**RE: Proposal to Address the Presence of DNAPL**  
**Upper ½-Mile Reach Removal Action**  
**General Electric-Housatonic River Site, Pittsfield, Massachusetts**

# Attachment 1

## Comments on DNAPL Proposal

Attachment 2

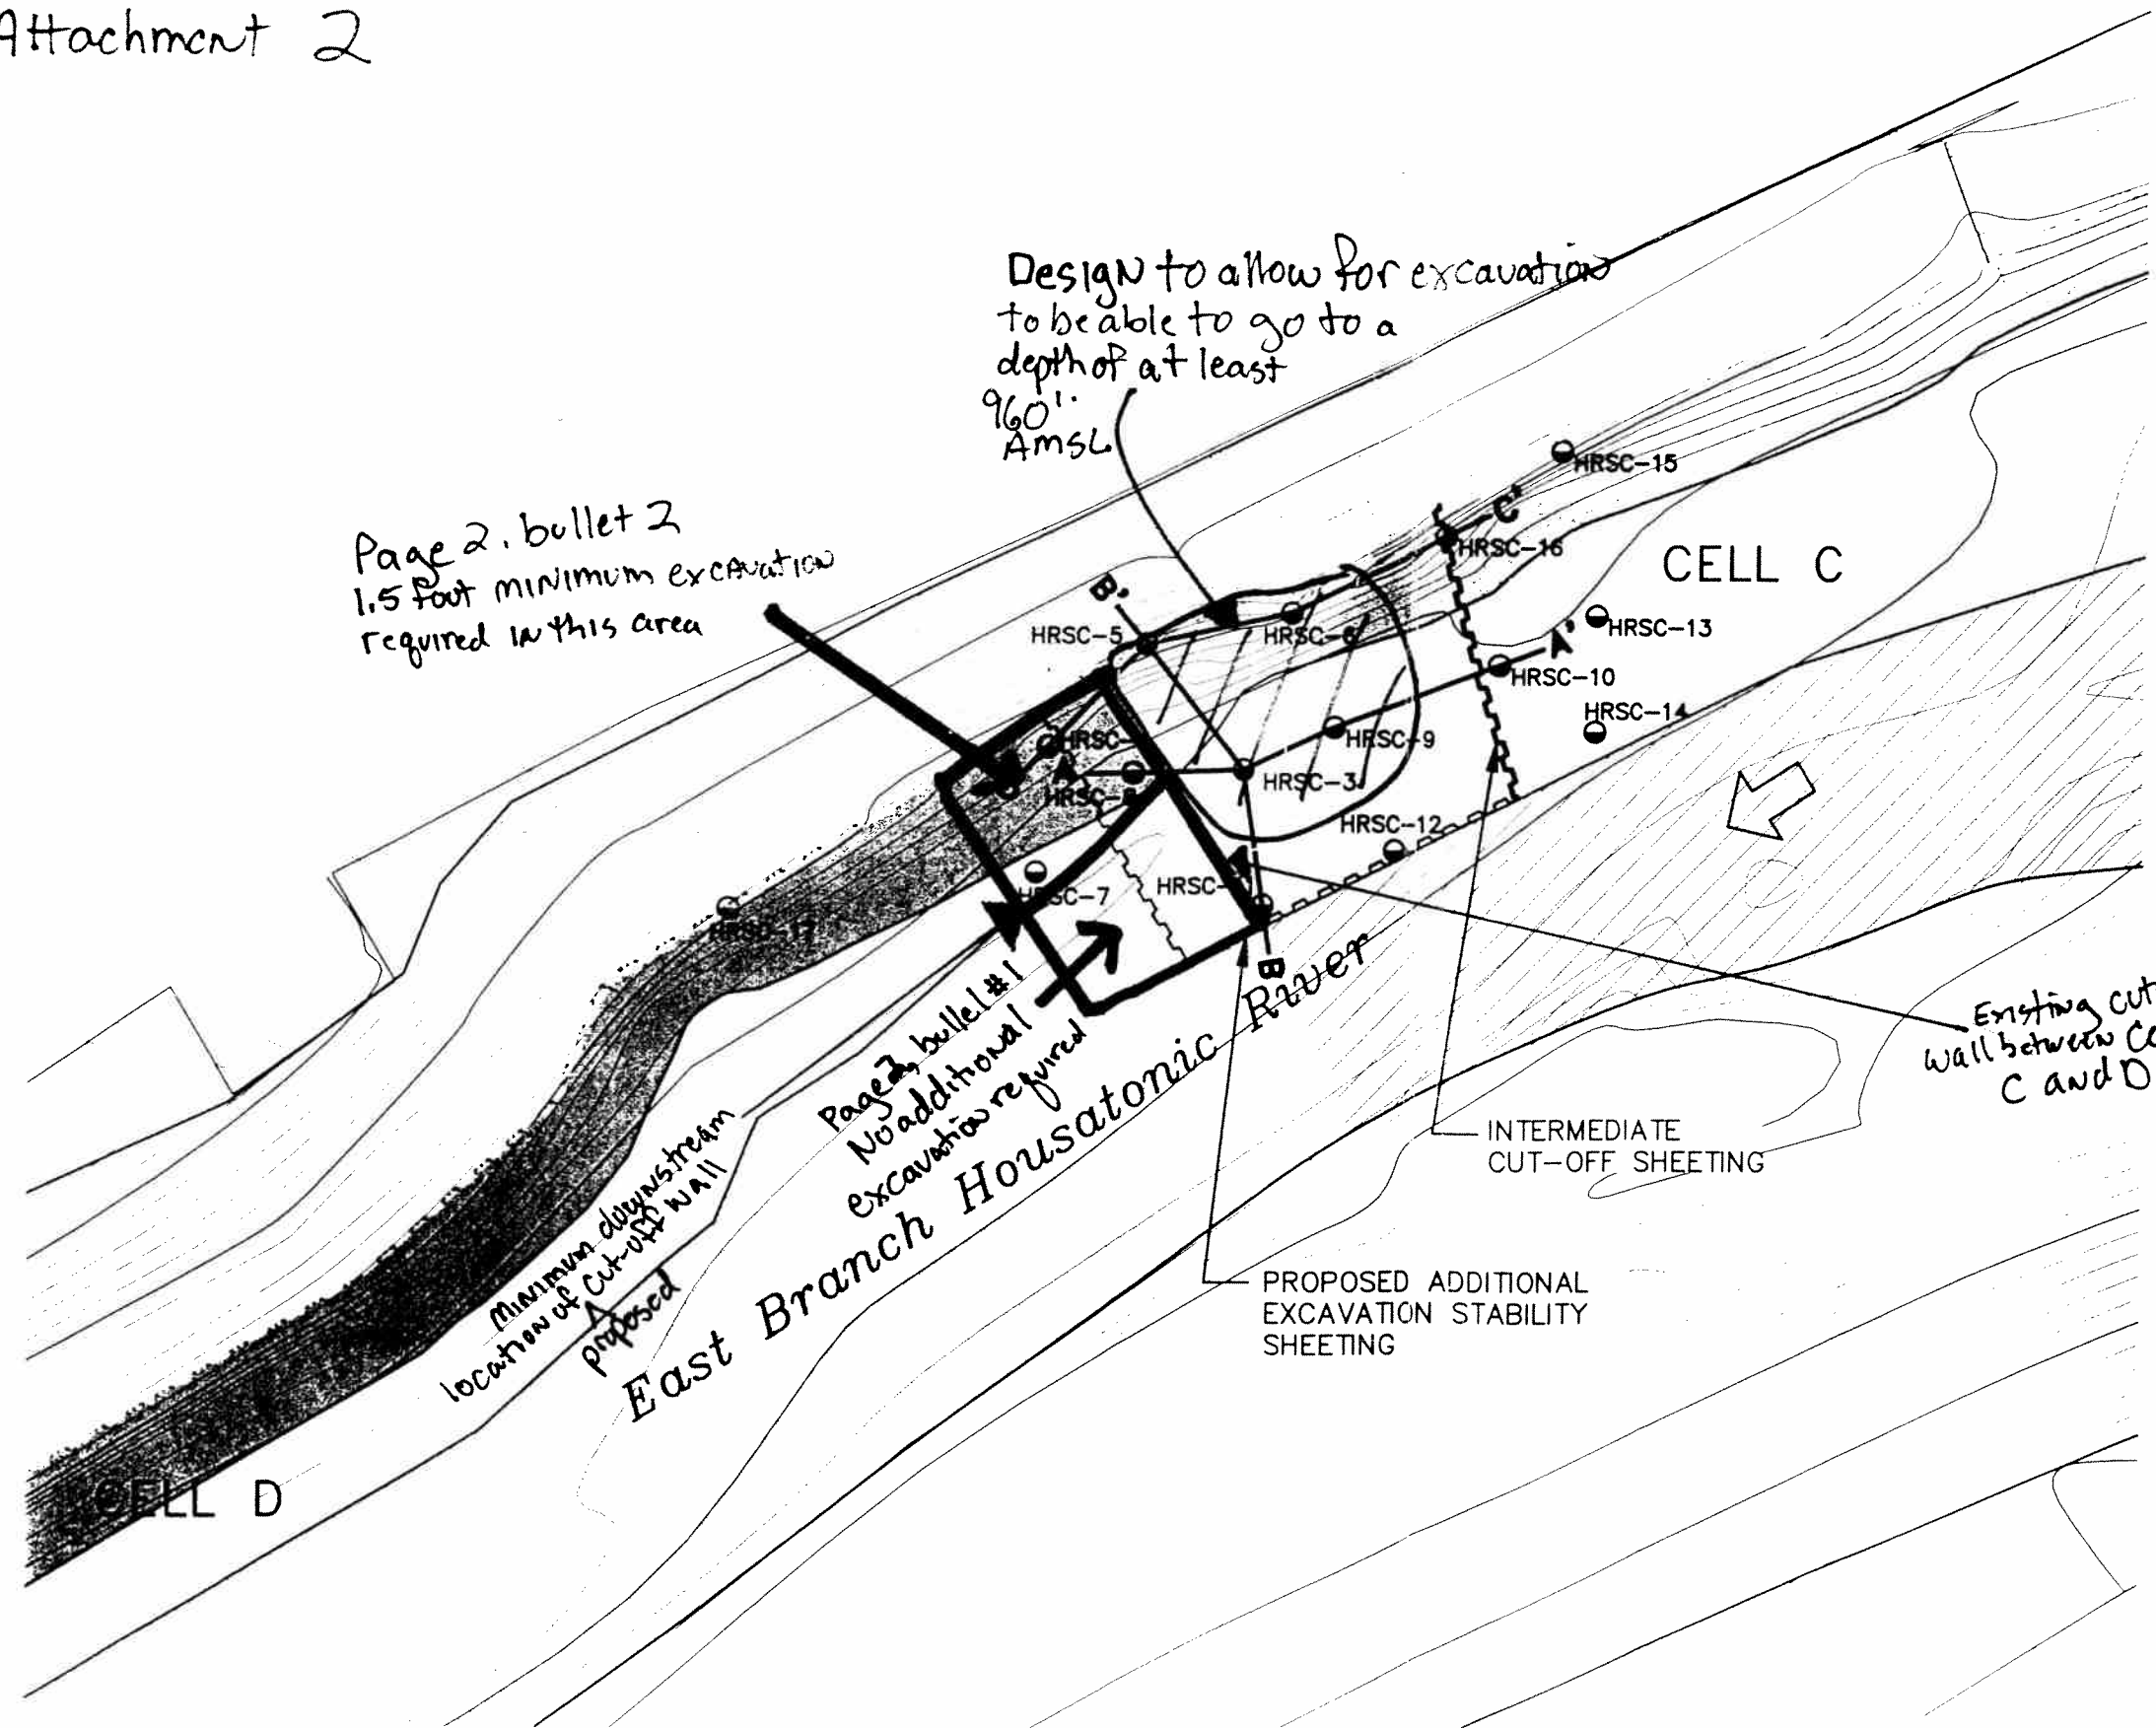
to depths greater than those proposed in the submittal. Specifically, I recommend that the design allow for the excavation to be safely performed to a depth of at least 960 feet above mean sea level (AMSL) in the area encompassing boring locations HRSC-3, 5, 6 and 9 (See Attachment #2).

Also, although free phase DNAPL was not detected in the piezometer installed at location HRSC-8, which is located within Cell D, there was significant staining observed in the soil boring between elevations 963.92 and 962.92 feet AMSL. This is close to the elevation where free-phase DNAPL was observed in the piezometer installed at HRSC-3 (962.11 feet AMSL). The distance between locations HRSC-3 and HRSC-8 is only 12 feet. Furthermore, location HRSC-8 is located within 5 feet of where the 3-foot diameter pipe was placed to isolate and recover the free-phase DNAPL and where GE/MTI have recovered at least 650 gallons of free-phase DNAPL. Therefore, it is possible that the DNAPL extends to location HRSC-8 and other areas within Cell D and GE should ensure that the proposed sheetpile layout and bracing procedures allow for excavation to be performed to the necessary depths in this area as well.

With regard to the proposed location of the downstream cutoff wall, I recommended that GE install the cutoff wall a minimum of 10 feet downstream from the proposed location. As Bill Horne and I discussed in the field, the sheetpile should be installed starting at or downstream of source control sheetpile # 127 and extend toward the centerline sheetpile where the 2-inch submersible pump is currently located. The relocation of the cutoff wall further downstream would allow for additional DNAPL removal to be performed in Cell D, should that be necessary. Bill Horne and I also discussed how the relocation of the downstream cutoff wall would affect proposed excavation activities in the Cell D and in the newly isolated area of the river. We agreed on the following:

- In the area currently outside of both Cell C and Cell D (See Attachment #2), GE would not be required to perform additional sediment excavation unless there is evidence that GE's excavation, dewatering, and DNAPL removal activities caused contamination to migrate into this area, or if the DNAPL that is present in Cell C at elevation 962 feet AMSL extends into this area.
- In the area bounded by: the existing cutoff wall located between Cells C and D; the existing Cell D centerline sheetpile wall; the newly installed downstream cutoff wall; and the source control sheets (See Attachment #2); GE shall excavate sediments in the entire area to a depth of 1.5 feet or to the minimum depths specified in the ½-Mile Work Plan, whichever is deeper.

Comments: Minimum limits of the excavation may need to be expanded.

Downstream location of the proposed cut-off wall may need to be extended 15 feet. Additional contingency.

Additional excavation of surficial contamination needs to be addressed. All surface areas with the DNAPL cell are currently smeared with DNAPL/sheens.
